## CAMERON PRAIRIE REFUGE PROTECTION (ME-09)

Figure 1. Project boundaries and features.

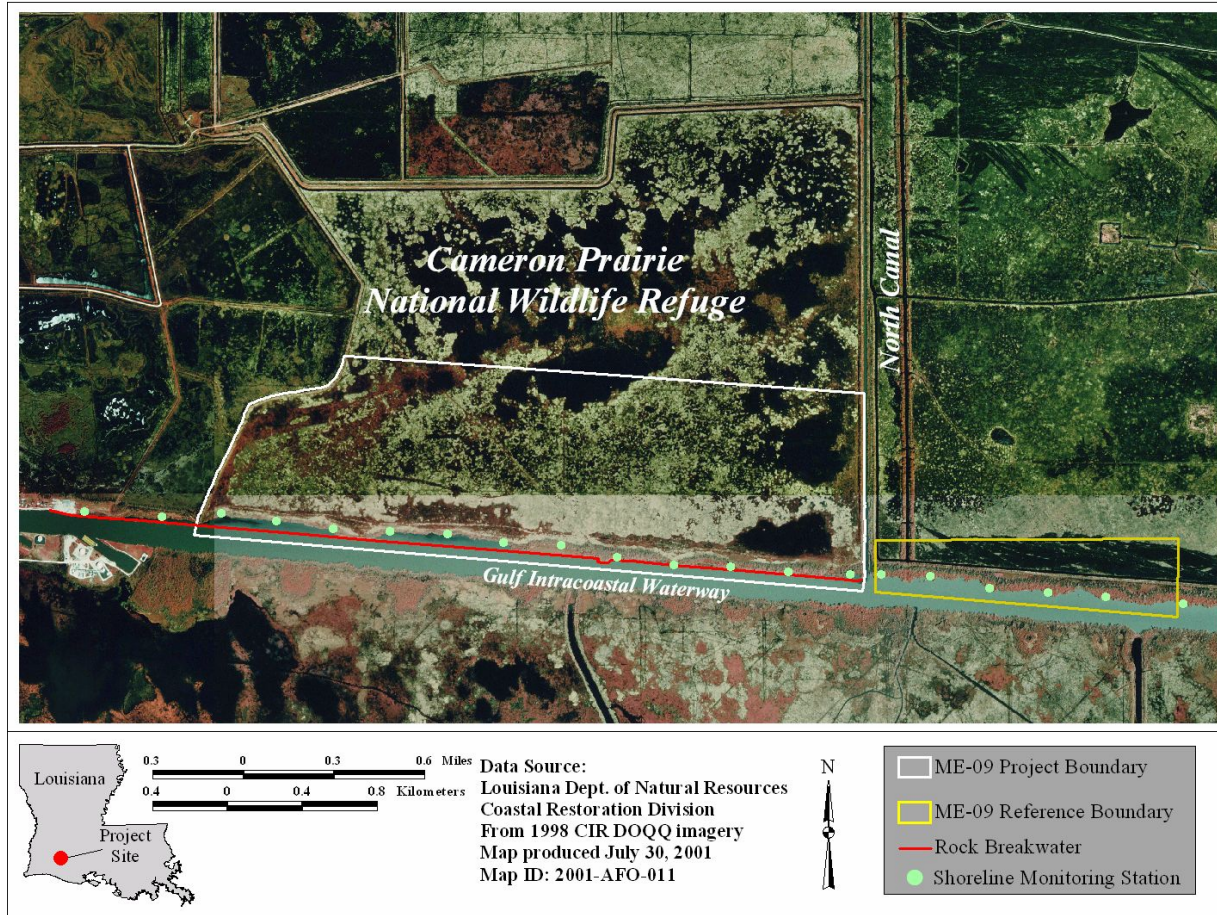
The Cameron Prairie Refuge project includes a 247 ac (100 ha) area located within 1,600 ac (648 ha) of wetlands in the Cameron Prairie National Wildlife Refuge, approximately 25 mi (40 km) southeast of Lake Charles in north central Cameron Parish (figure 1). The project area borders the north bank of the Gulf Intracoastal Waterway (GIWW). Since the construction of the GIWW (between 1935 and 1940) wave erosion on the north bank of the channel has accelerated significantly due to increased utilization by navigational vessels. This energy has

The GIWW borders the project area to the south and threatens to breach into the refuge. Wave action caused by boat traffic within the GIWW has eroded most of the spoil banks that protect the refuge, allowing the high energy saline waters of the GIWW to enter the project area. The resulting wave energy and saltwater

intrusion has impacted the fragile interior freshwater wetlands, and could potentially result in a “blowout”, causing considerable wetland loss (Cameron Prairie National Wildlife Refuge 1991).
